Office Action Summary	Application No.	Applicant(s)	
	10/612,229	HENSLEY ET AL. 	
	Examiner	Art Unit	
	Khiem D. Nguyen	2823

DETAILED ACTION

Claims 1-7, 21-28, 37-55, 58-65, 68, 71-76 and 77-80 are rejected under 35 U.S.C. 103(a) as being unpatentable over the applicant's admitted prior art (AAPA) of this application in view of Tokunoh et al. (U.S. Patent 5,543,363) and Yang et al. (U.S. Patent 6,09,902).

FIG. 1

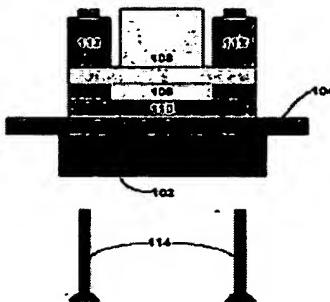
In re claim 1, AAPA discloses a method to assemble a pre-curved bolster plate **102** to one side of a substrate **104** having a first side (top) and a second side (bottom), comprising: attaching a component **106** to an electrical contact area on the first side of the substrate **104**; and attaching the bolster plate **102** on the second side of the substrate

104, wherein the bolster plate 102 is attached to the second side opposite the electrical contact area on the first side of the substrate 104 (Description of the Prior Art, lines 3-22 and FIG. 1).

AAPA does not explicitly disclose that the bolster plate is a pre-curved bolster plate that has a radius of curvature where the radius is pre-calculated by a method.

FIG. 3 (BACKGROUND ART)

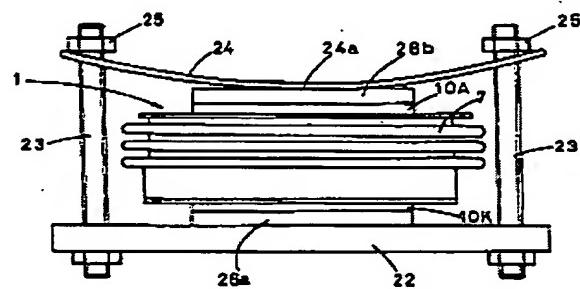
Tokunoh, however, discloses attaching a pre-curved bolster plate 24 on the second side (top) of the substrate 26b opposite to the electrical contact area on the first side (bottom) of the substrate wherein the pre-curved bolster plate has a radius of curvature where the radius is pre-calculated by a method (col. 3, lines 38-60 and FIG. 3).

Therefore, it would have been obvious to one of ordinary skill in the art at the time of the invention was made to combine the teaching of AAPA and Tokunoh to enable the process of attaching a pre-curved bolster plate on the second side of the substrate of AAPA to be performed and furthermore to protect the semiconductor element 1 (Abstract, Tokunoh).

FIG. 3

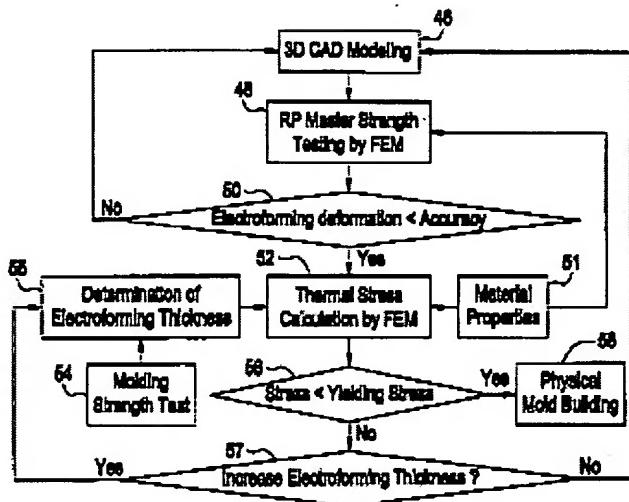
Yang, however, discloses that the radius of curvature of the pre-curved bolster plate is pre-calculated by a method comprising: estimating an initial radius of curvature of the pre-curved bolster plate by use of a hand calculation, based upon a uniform load from a clamping force to be applied on the component that will be attached to the substrate; modeling the pre-curved bolster plate with the initial radius, by use of a computer aided design software (3D CAD) (col. 7, lines 19-30 and FIG. 3); and

determining a final radius of curvature by use of a finite element analysis software so that the pre-curved bolster plate will deflect to a flat plate after the clamping force is applied to the component, substrate, and pre-curved bolster plate, wherein the step of determining the final radius of curvature comprises modifying the initial radius to the final radius (col. 7, lines 31-41 and FIG. 3).

Therefore, it would have been obvious to one of ordinary skill in the art at the time of the invention was made to combine the teaching of AAPA, Tokunoh, and Yang to enable the process of pre-calculated the radius of curvature of the pre-curved bolster plate using computer aided design software and the finite element analysis software of AAPA and Tokunoh to be performed and furthermore to minimize the manufacturing time and cost while satisfy the tooling requirement (Abstract, Yang).

F I G . 3 (BACKGROUND ART)

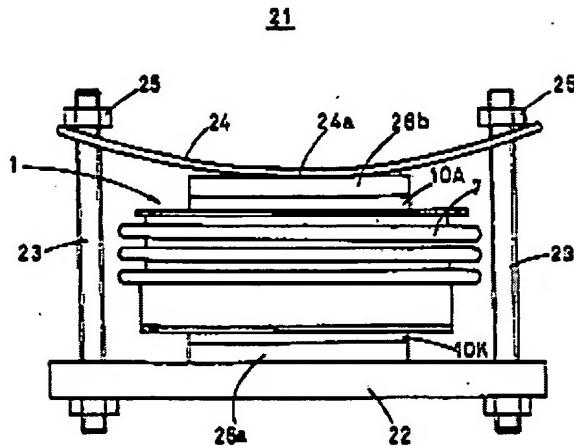
Tokunoh, however, discloses attaching a pre-curved bolster plate 24 on the second side (top) of the substrate 26b opposite to the electrical contact area on the first side (bottom) of the substrate wherein the pre-curved bolster plate has a radius of curvature prior to attachment to the second side of the substrate 26b, where the radius is pre-calculated by a method (col. 3, lines 38-60 and FIG. 3).

Therefore, it would have been obvious to one of ordinary skill in the art at the time of the invention was made to combine the teaching of AAPA and Tokunoh to enable the process of attaching a pre-curved bolster plate on the second side of the substrate of AAPA to be performed and furthermore to protect the semiconductor element 1 (Abstract, Tokunoh).

FIG. 3

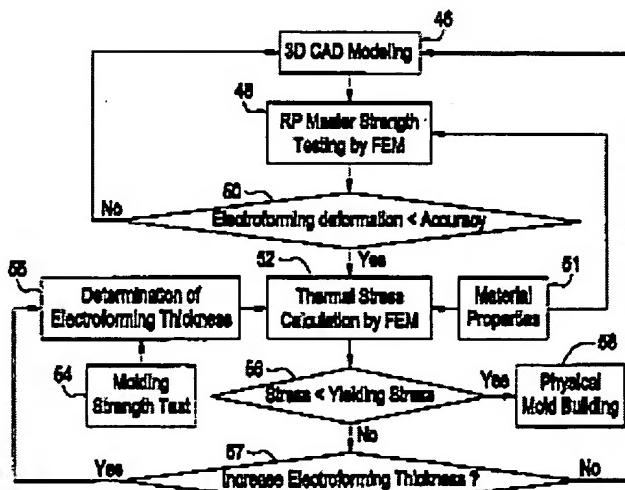
Yang, however, discloses that the radius of curvature of the pre-curved bolster plate is pre-calculated by a method comprising: estimating an initial radius of curvature of the pre-curved bolster plate by use of a hand calculation, based upon a uniform load from a clamping force to be applied on the component that will be attached to the substrate; modeling the pre-curved bolster plate with the initial radius, by use of a computer aided design software (3D CAD) (col. 7, lines 19-30 and FIG. 3); and determining a final radius of curvature by use of a finite element analysis software so that the pre-curved bolster plate will deflect to a flat plate after the clamping force is applied to the component, substrate, and pre-curved bolster plate, wherein the step of determining the final radius of curvature comprises modifying the initial radius to the final radius (col. 7, lines 31-41 and FIG. 3).

Therefore, it would have been obvious to one of ordinary skill in the art at the time of the invention was made to combine the teaching of AAPA, Tokunoh, and Yang to

enable the process of pre-calculated the radius of curvature of the pre-curved bolster plate using computer aided design software and the finite element analysis software of AAPA and Tokunoh to be performed and furthermore to minimize the manufacturing time and cost while satisfy the tooling requirement (Abstract, Yang).

FIG. 3 (BACKGROUND ART)

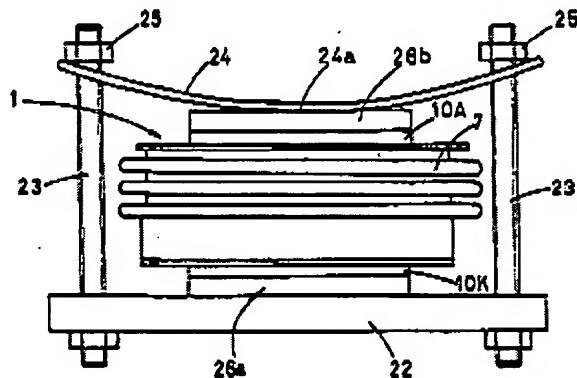
Tokunoh, however, discloses attaching a pre-curved bolster plate 24 on the second side (top) of the substrate 26b opposite to the electrical contact area on the first side (bottom) of the substrate wherein the pre-curved bolster plate has a radius of curvature prior to attachment to the second side of the substrate 26b, where the radius is pre-calculated by a method (col. 3, lines 38-60 and FIG. 3).

Therefore, it would have been obvious to one of ordinary skill in the art at the time of the invention was made to combine the teaching of AAPA and Tokunoh to enable the process of attaching a pre-curved bolster plate on the second side of the substrate of AAPA to be performed and furthermore to protect the semiconductor element 1 (Abstract, Tokunoh).

FIG. 3

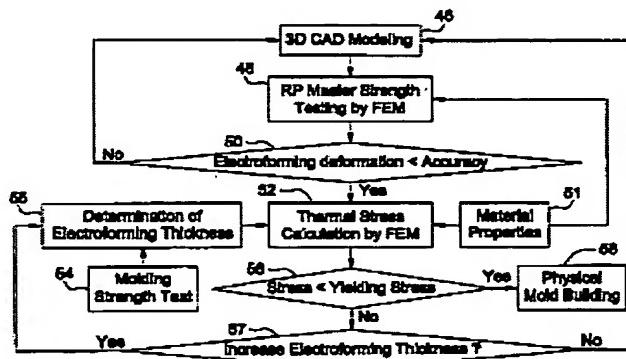
Yang, however, discloses that the radius of curvature of the pre-curved bolster plate is pre-calculated by a method comprising: estimating an initial radius of curvature of the pre-curved bolster plate by use of a hand calculation, based upon a uniform load from a clamping force to be applied on the component that will be attached to the substrate; modeling the pre-curved bolster plate with the initial radius, by use of a computer aided design software (3D CAD) (col. 7, lines 19-30 and FIG. 3); and

determining a final radius of curvature by use of a finite element analysis software so that the pre-curved bolster plate will deflect to a flat plate after the clamping force is applied to the component, substrate, and pre-curved bolster plate, wherein the step of determining the final radius of curvature comprises modifying the initial radius to the final radius (col. 7, lines 31-41 and FIG. 3).

Therefore, it would have been obvious to one of ordinary skill in the art at the time of the invention was made to combine the teaching of AAPA, Tokunoh, and Yang to enable the process of pre-calculated the radius of curvature of the pre-curved bolster plate using computer aided design software and the finite element analysis software of AAPA and Tokunoh to be performed and furthermore to minimize the manufacturing time and cost while satisfy the tooling requirement (Abstract, Yang).

FIG. 3 (BACKGROUND ART)

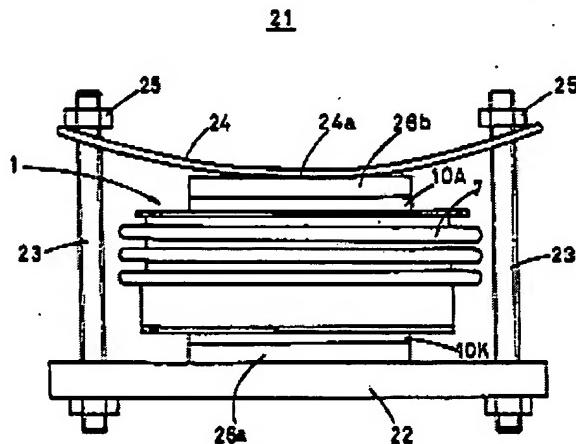
Tokunoh, however, discloses attaching a pre-curved bolster plate 24 on the second side (top) of the substrate 26b opposite to the electrical contact area on the first side (bottom) of the substrate wherein the pre-curved bolster plate has a radius of curvature prior to attachment to the second side of the substrate 26b, where the radius is pre-calculated by a method (col. 3, lines 38-60 and FIG. 3).

Therefore, it would have been obvious to one of ordinary skill in the art at the time of the invention was made to combine the teaching of AAPA and Tokunoh to enable the process of attaching a pre-curved bolster plate on the second side of the substrate of AAPA to be performed and furthermore to protect the semiconductor element 1 (Abstract, Tokunoh).

FIG. 3

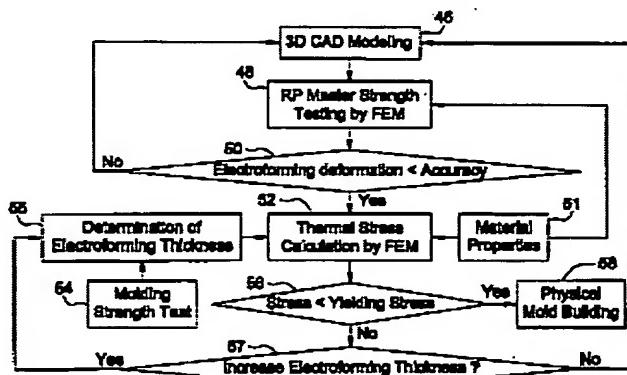
Yang, however, discloses that the radius of curvature of the pre-curved bolster plate is pre-calculated by a method comprising: estimating an initial radius of curvature of the pre-curved bolster plate by use of a hand calculation, based upon a uniform load from a clamping force to be applied on the component that will be attached to the substrate; modeling the pre-curved bolster plate with the initial radius, by use of a computer aided design software (3D CAD) (col. 7, lines 19-30 and FIG. 3); and

determining a final radius of curvature by use of a finite element analysis software so that the pre-curved bolster plate will deflect to a flat plate after the clamping force is applied to the component, substrate, and pre-curved bolster plate, wherein the step of determining the final radius of curvature comprises modifying the initial radius to the final radius (col. 7, lines 31-41 and FIG. 3).

Therefore, it would have been obvious to one of ordinary skill in the art at the time of the invention was made to combine the teaching of AAPA, Tokunoh, and Yang to enable the process of pre-calculated the radius of curvature of the pre-curved bolster plate using computer aided design software and the finite element analysis software of AAPA and Tokunoh to be performed and furthermore to minimize the manufacturing time and cost while satisfy the tooling requirement (Abstract, Yang).
